RE: NBHS Physical Science Center - BG 24-192 - Change Order 10 - Exterior Framing, Site Walls and Fencing **DC**

Phase II Athletics - Bid Package No. 2 -
NB Field House
Bullitt County Public Schools

Change Order Number: 010

4 WALL SECTION - NBHS EXTERIOR LOW WALL
1" = 1'-0"

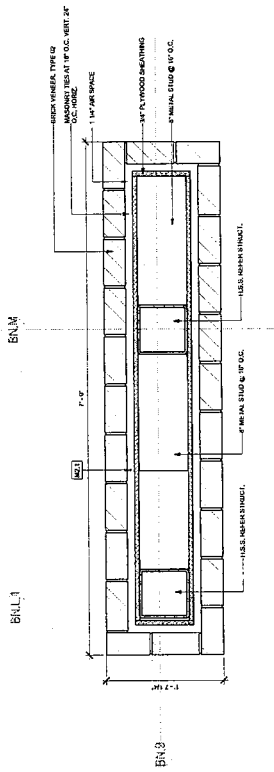
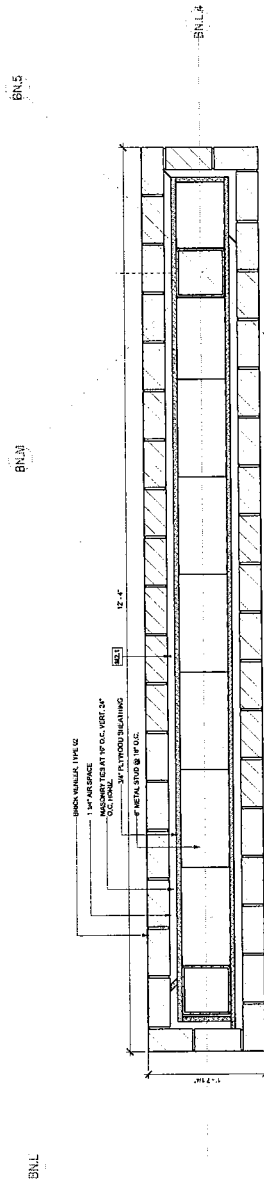
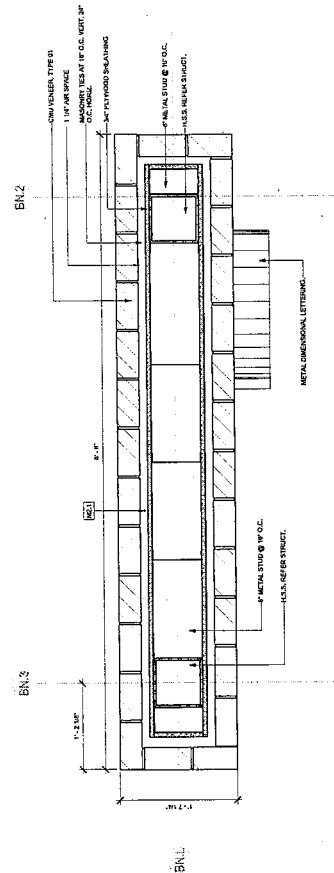
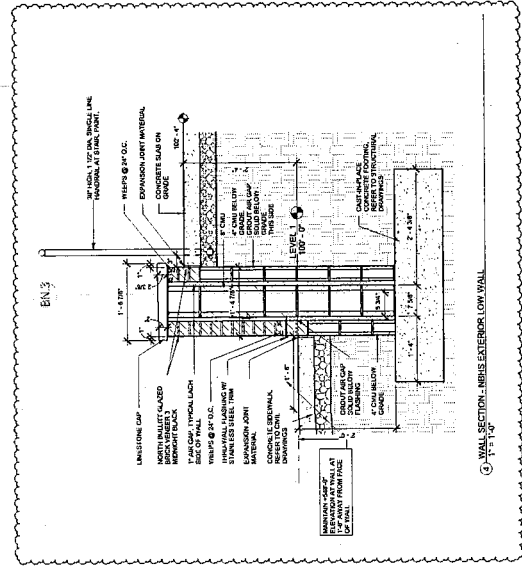
- Item 1:** Refer to Drawing A1.31 NBHS
- Section Cut added at Exterior Low Wall.
- Item 2:** Refer to Drawing A5.23 NBHS
- Wall Section Detail #4 added showing limestone cap profile and clarification to wall construction.
 - Exposed Masonry Veneer to be North Bullitt Glazed Brick Veneer Type 3: Midnight Black
 - Please note, exterior elevation along low wall to be +548'-0".

Item 1. Refer to Drawing A5.30

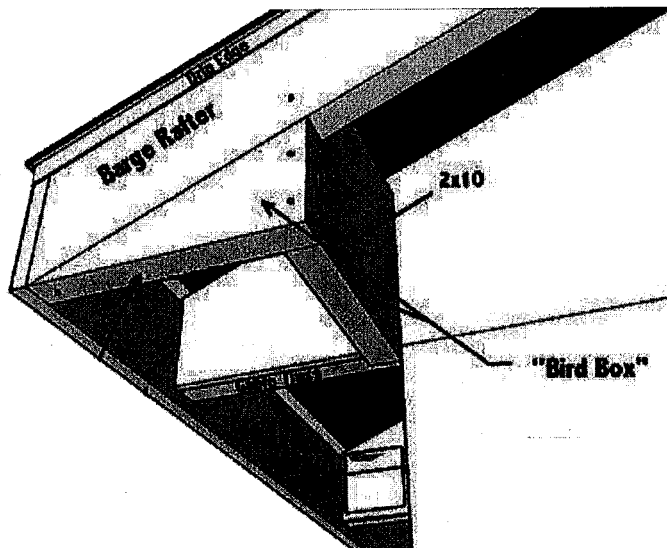
- See update to Detail #7. Treating Plywood added to 2x nailer board.
- Gutter to be lowered to align with bottom of soffit J-Trim.
- Use of a Bird Box detail at the corners where the eave transitions to the rake is acceptable.
